Phase 3 Residential Development, Ballymastone, Donabate, Co. Dublin

Stage 1 Road Safety Audit

20003-DBF-XXXX-XX-RP-C01-000107

October 2025

2.1.2 Location (G2) - Visibility at Junctions

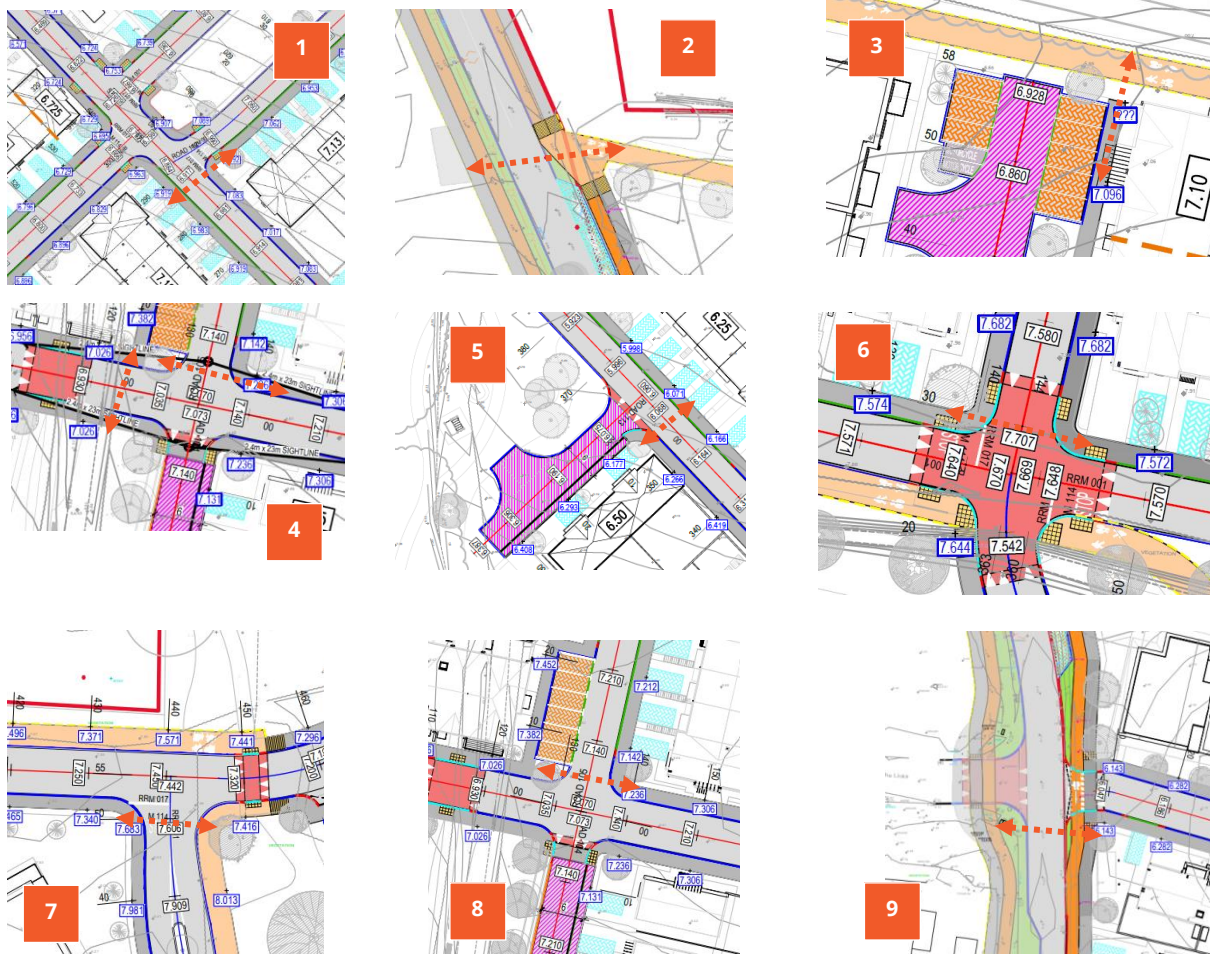
It is noted that the extent of available clear unobstructed visibility splay for vehicle drivers at Home Zone (Road 143 & 144) / Link Street junctions could potentially be obstructed by vehicles parked within the proposed adjoining perpendicular car parking bays and tree planting along the Link Street. This may lead to collisions between vehicles, pedestrians, or cyclists.

It is recommended that appropriate visibility splays to approaching vehicles should be provided at all junctions. Ensure that the visibility envelope should be kept clear of any obstruction including landscaping which should be no higher than 0.6m and/or accommodate a tree specified with a small diameter trunk with elevated canopy outside / above of the visibility splay.

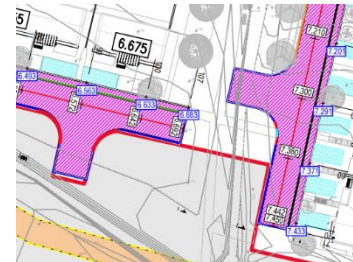
It is recommended that appropriate and consistent kerb should be provided at the Home Zone locations. If the same surface treatment is to be specified for the shared carriageway and the parallel defensible area then the kerb between these two areas should be constructed flush to remove the trip hazard.

2.1.15 Location (G15) Bicycle Parking

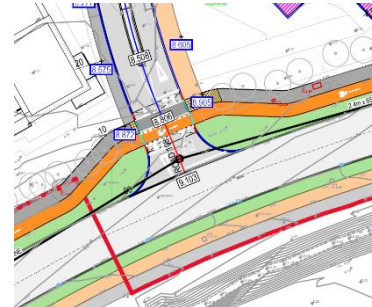
The scheme drawings presented for the purpose of this audit do not seem to detail the provision of visitor (short term) bicycle parking for the 'house' units. In the absence of formal bike parking opportunities visitor bikes might be locked to street furniture in a manner that gives rise to a trip hazard for active travel users.

It is recommended that an element of visitor bicycle parking is provided at strategic attractive locations across the residential scheme. The design of this bicycle parking should provide the necessary security characteristics, located in a convenient and accessible location and not give rise to blockages / trip hazards along any adjoining pedestrian / cycle routes.

2.2.4 Location (S4) – Visibility at Site Access along The Links

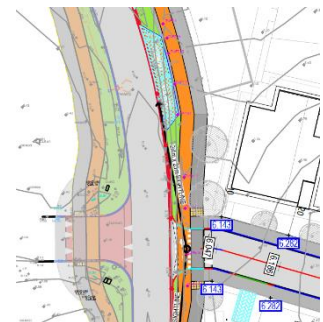
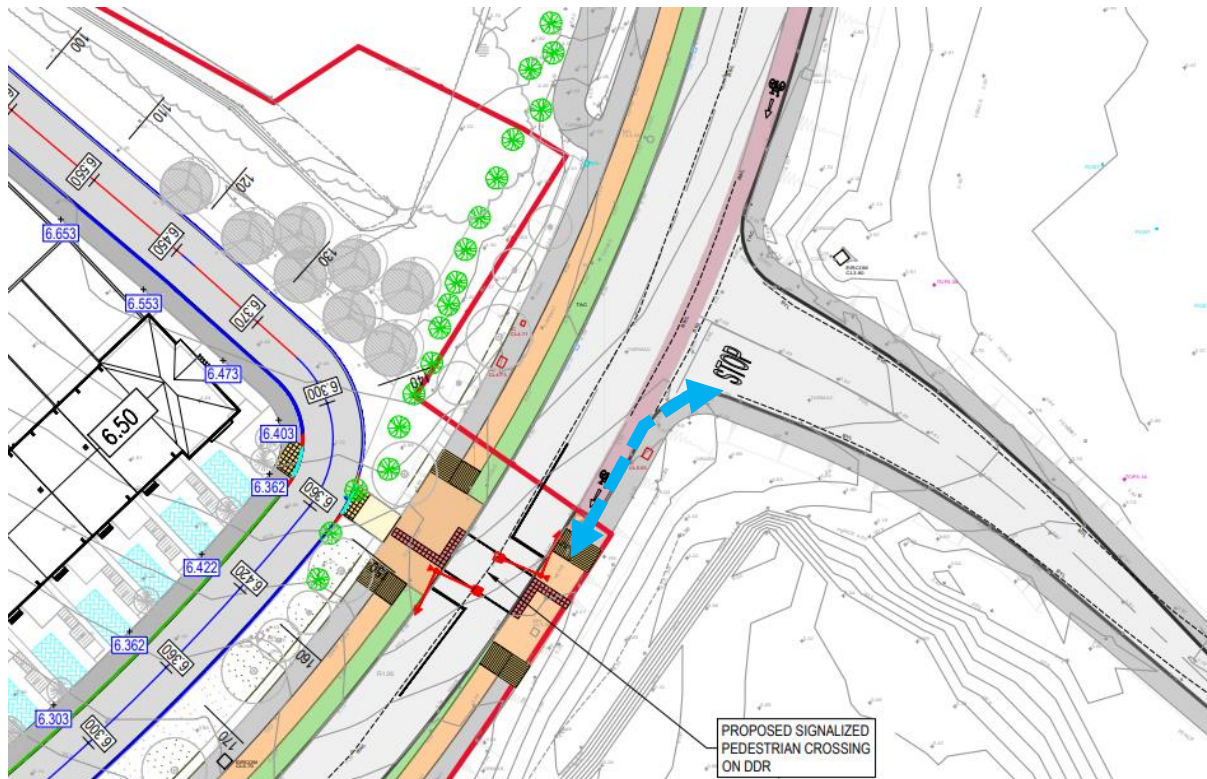
The development proposed a site access from The Links road which forms a four arm junction. The auditors note that there is an existing set down area along The Links road adjacent the site access. Vehicles particularly high sided commercial (Van etc) and SUV's parled in the set down area may partially obstruct visibility for vehicle drivers exiting the proposed new site access. This may lead to side swipe collisions.

It is recommended that the set down area should be reassigned to bicycle parking or similar so that visibility for the vehicle drivers exiting the subject site will not be obstructed.

2.2.6 Location (S6) – Vehicle Access on Distributor Road

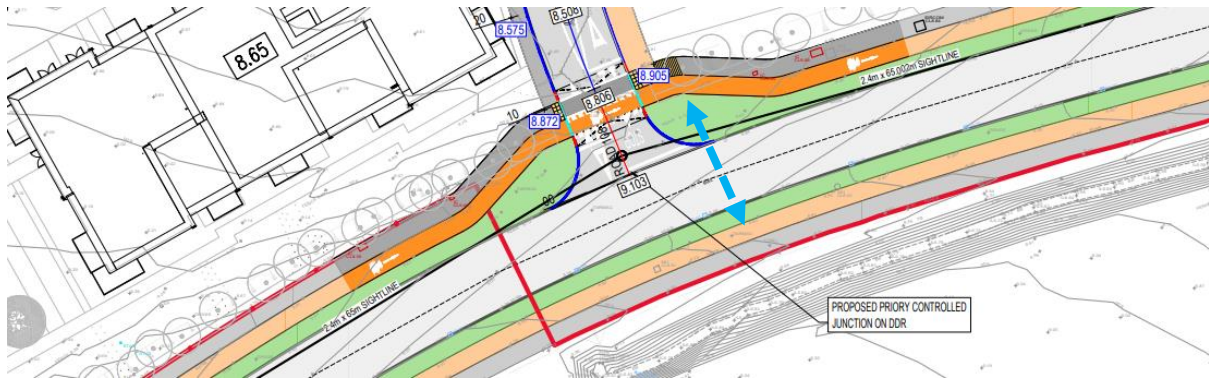
The introduction of a new site access gives rise to a new travel design line for both pedestrians and cyclists to cross the distributor road carriageway in the general area of the site access junction (to access the footpath and southbound cycle track). In the absence of a Pedestrian and Cycle connection active travellers are required to cross the grass verge and raised kerbs which represent both a trip and slip type hazard.

The design of the new site access junction with the existing distributor road should accommodate the active travel desire line across the distributor road carriageway in this general location.

2.2.7 Location (S7) – Shared Path to Zebra Crossing

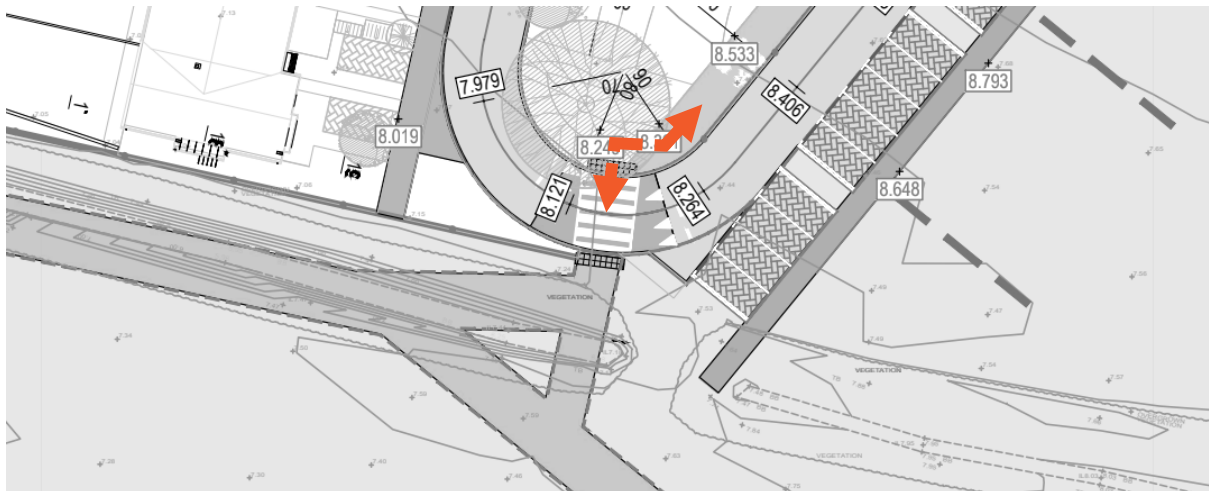
The shared ped/cycle path does not seem to extend / tie-in with the proposed Zebra crossing. In the absence of a continued path a trip hazard may be present.

The scheme designers are asked to confirm that the shared path extends all the way to/from the proposed zebra crossing.

2.2.8 Location (S8) – Zebra Crossing Design

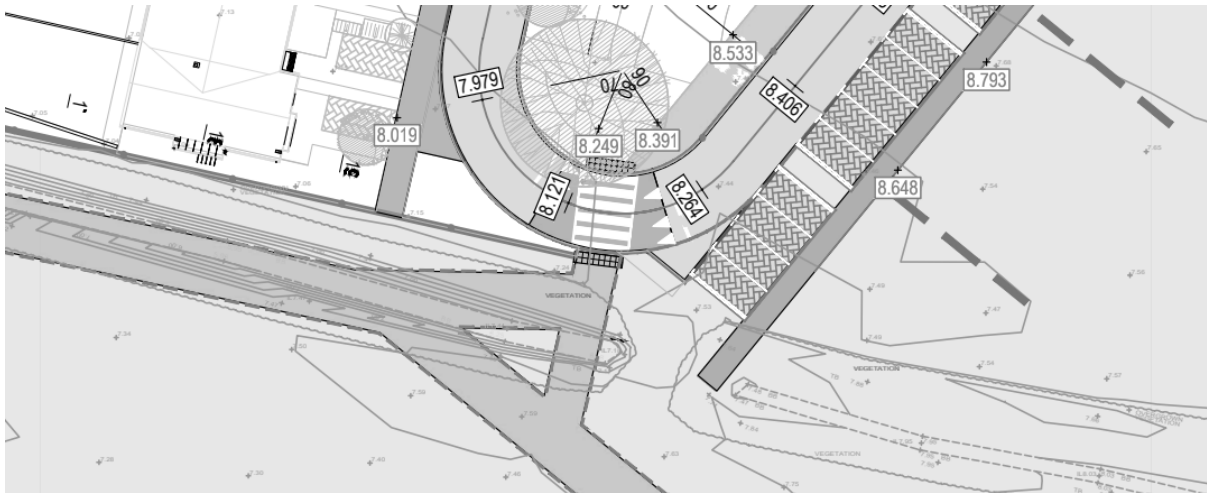
Zebra crossing road markings provided but incorrect tactile details and no beacon / signs provided. Potential confusion regarding who has right of way leading to potential conflict between active travel users and moving vehicles on the crossing point.

Clarification regarding the intended crossing type. Design Zebra crossing as per appropriate guidance with correct tactile and signage provided. Ensure that appropriate clear unobstructed forward visibility is provided between vehicle drivers (approaching the crossing) and active travel users about to step onto the Zebra crossing.

2.2.9 Location (S9) – Long Straight Road

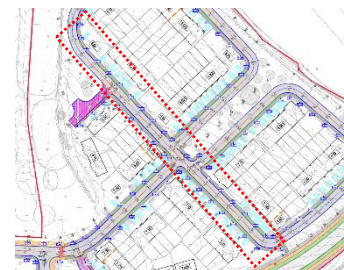
The development proposed a long straight section of road located north east of the site access along Donabate Distributor Road. This may encourage high speed leading to collisions between vehicles, pedestrians or cyclists.

It is recommended that appropriate traffic calming measure should be implemented.

2.3.2 Location (C2) – Bespoke Signages at The Links

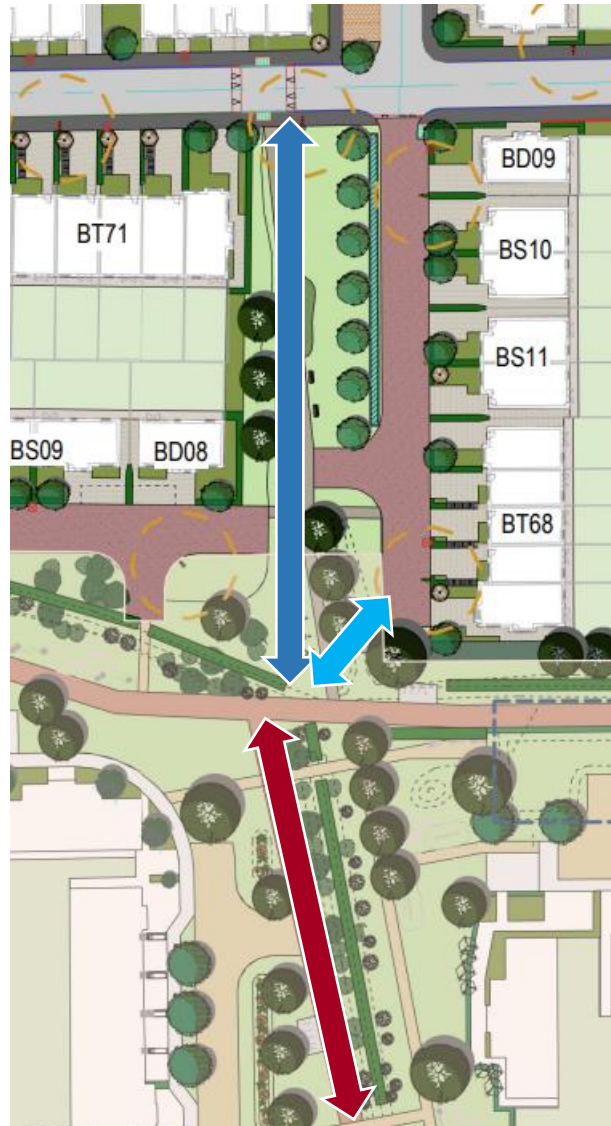
It was observed during the site visit that Bespoke signages (Shared Space) at Zebra Crossing along The Links adjacent Road 114 which is confusing. Appropriate standard signages should be provided.
